DPHI	Comment	Applicant Response
		The GFA drawings have been amended such that the stairs to the commercial units have been excluded from the calculation of GFA. Refer Appendix D .
	<p><i>In relation to the updated design of the residential corridors:</i></p> <ul style="list-style-type: none"> ▪ <i>provide a cross section plan of the residential corridors and typical detailed elevation (at a smaller scale) of the corridors.</i> ▪ <i>discuss the new corridor configuration including (but not limited too) whether the area between the internal wall/door and external façade will be accessible by residents, how the new design allows for acceptable amenity to the corridors as required by the ADG and wind mitigation.</i> 	<p>Drawing DA801 (Rev 01) (<i>Residential Corridor Concept Details</i>) in the revised architectural plans (Appendix E):</p> <ul style="list-style-type: none"> ▪ Provides a cross section and detailed elevation of a typical residential corridor (Level 16, Tower A). ▪ Details the new corridor configuration, including the areas between the internal wall / door and external façades for maintenance access to mechanical plant areas (i.e. not accessible by residents). ▪ Describe

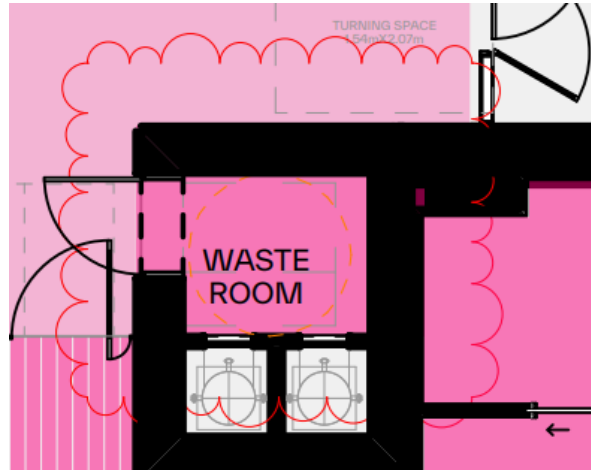
Waste room circulation spaces on Levels 3-35 have not been identified as GFA.

The GFA drawings have been updated to include the waste room circulation spaces at Levels 03 – 35 as GFA (**RTS Appendix D**). A typical plan extract is below.

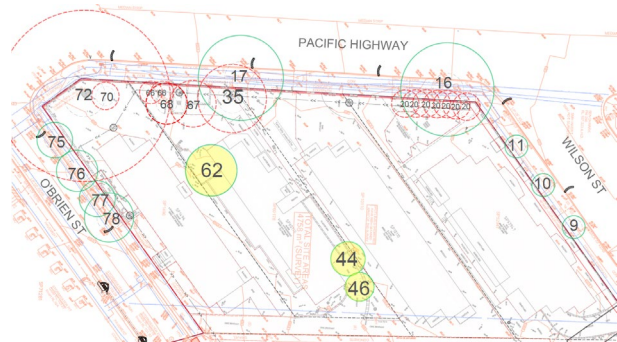
Additional trees are proposed to be removed including a high retention value tree and multiple moderate retention value trees. The RtS must discuss why it is acceptable to remove these trees and what measures were considered for tree retention.

Additionally, the Arborist Report submitted with the EIS included recommendations for retention of some trees and it is unclear why those measures could not be implemented to retain the trees. For example (but not limited to):

- *Tree 72 (high value) – the updated report advises a temporary substation and the footpath will encroach the SRZ. The location of the footpath has not changed since the EIS. It is also unclear why a temporary substation could not be located elsewhere on the site and why it is acceptable for a temporary item to require removal of a high significance tree.*

- *Trees 35, 67 (moderate value), 68 – the updated report advises a footpath will encroach the SRZ however the location of the footpath has not changed since the EIS. The arborist report submitted with the EIS recommended footpath design and construction methods to retain this tree.*

- **7 x trees for removal** (Reference # 20(7), 35, 66(x4), 67, 68, 70, and 72). **The trees identified for removal are all located within the subject site.** A total of 7 x replacement trees are required (45L volume pots) to compensate for the removal of High, Moderate, and Low-Moderate Value trees resulting in a canopy replacement of 907 sqm.
- **12 x trees for retention** (Reference # 9, 10, 11, 16, 17, 44, 46, 62, 75, 76, 77, and 78). **The trees identified for retention are located within the public domain and the subject site.**

The AIA includes a revised Tree Retention and Removal Plan (extracted below). This confirms that all 9 x trees in the public domain will be retained (identified in **green**).
